Environmental Impact Report

Inland Empire North Logistics Center Apple Valley

State Clearinghouse No. 2023090366

MARCH 2025

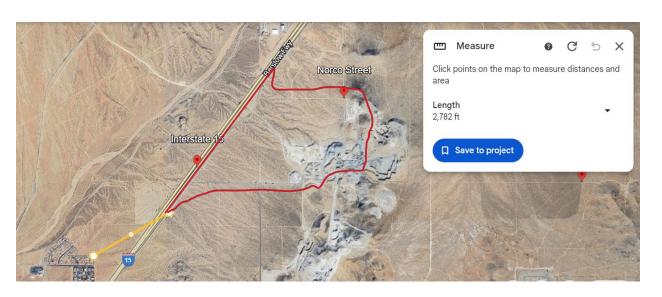
The screenshot above shows an underestimation of approximately 788 feet for the distance to the nearest sensitive receptor, compared to the value provided in the DEIR.³ Furthermore, the nearest residential receptor is located 2,981 feet from the edge of the road work being conducted by the Project, which leads to an additional underestimation of 1,918 feet (see screenshot below)(DEIR, p. 3-17, Figure 3-3).4

⁴ 4,700 feet (DEIR's estimation) – 2,981 feet (SWAPE's estimation) = 1,918 feet

The DEIR relies upon this distance to calculate the Project's potential cancer risk to nearby receptors (p. 4.2-38, Table 4.2-7; p. 4.2-28, Table 4.2-8). Until this value is verified, the DEIR's HRA should not be relied upon as the basis for determining the Project's significance.

Figure 4: Existing And Approved Warehouse Projects Near Project

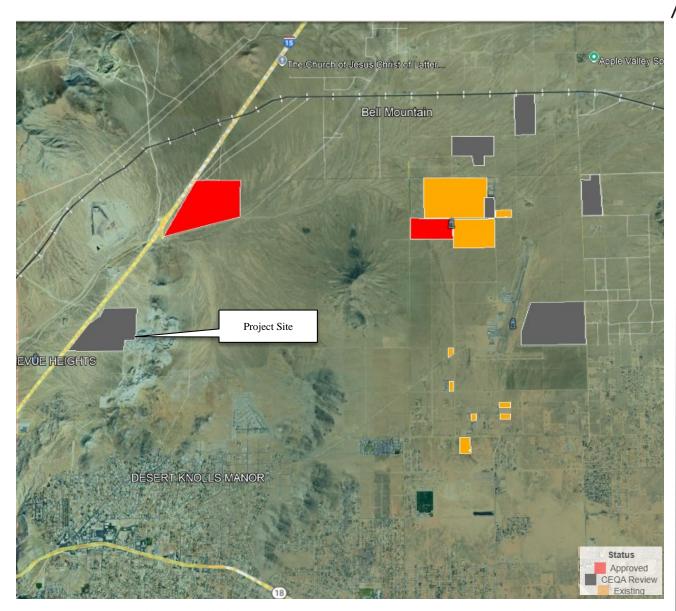
Within 10 kilometers of the project site, there are 9 existing warehouse projects (1 of which is vacant) totaling 9.038 million square feet. The Town is currently reviewing 5 new warehouse projects, including this Project, adding 15.777 million square feet of warehouse space. The Town approved two projects that total 7.667 million square feet of warehouse space.

According to data from the Redford Conservancy at Pitzer College and Radical Research LLC (presented on the Warehouse CITY website)³, the existing projects generate 6,000 daily truck trips, producing 8.3 pounds (lbs) of diesel particulate matter (DPM) and 935 lbs of oxides of nitrogen (NO_x) per day. The 2 approved projects will add 5,000 daily truck trips, contributing 6.9 lbs of DPM and 779 lbs of NO_x per day. The projects under review, inclusive of the Project, will add 11,000 daily truck trips, contributing 15.2 lbs of DPM and 1,714 lbs of NO_x per day. The Project itself will further

Figure 8: Valley Fever Incidence And Soil Disturbance

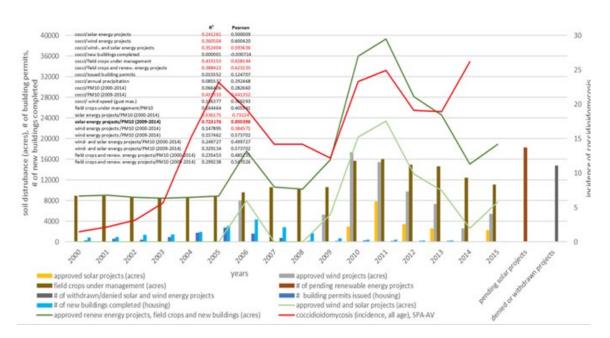
It is evident from the figure above that, as the number of acres of soil in the Antelope Valley were disturbed, the incidence rate of Valley Fever also increased. The mass disturbance of soils anticipated by the proposed Project will create the same conditions that were detailed in the study by Colson. ¹⁷

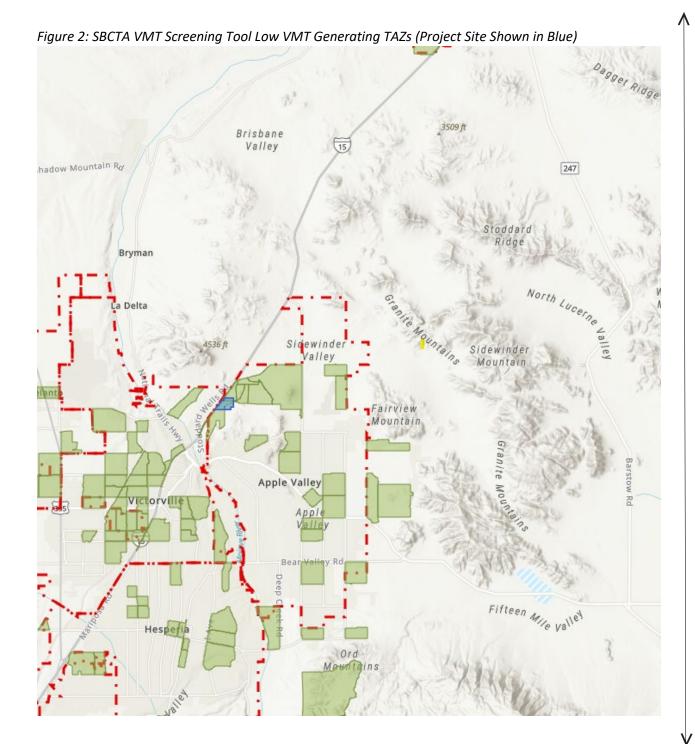
There are significant limitations in the ability of SBTAM to accurately estimate VMT at the project location because it is at the edge of an urbanized area adjacent to a large mostly unpopulated desert area. In the model, Transportation Analysis Zones ("TAZs") in the vicinity of the project vary greatly in size, which complicates estimating VMT. Much of the VMT in the larger TAZs is "intrazonal,", i.e. VMT representing trips completed within a single TAZ, and intrazonal VMT is only estimated crudely in the model.

The SBCTA VMT Screening Tool¹ is based on SBTAM and shares the same TAZ structure. Figure 2 shows Low-VMT Generating TAZs for the Town of Apple Valley's designated VMT metric, OD VMT Per Service Population.

10-40 Cont. In Figure 2, most of the project site, shown in blue, is shown as within a low-VMT generation TAZ, but some of the site is not, and the site is bordered by large areas that are not in low VMT-generating TAZs. In this transitional area between an urbanized area and a mostly unpopulated desert, the model distinctions between adjacent TAZs are not reliable.
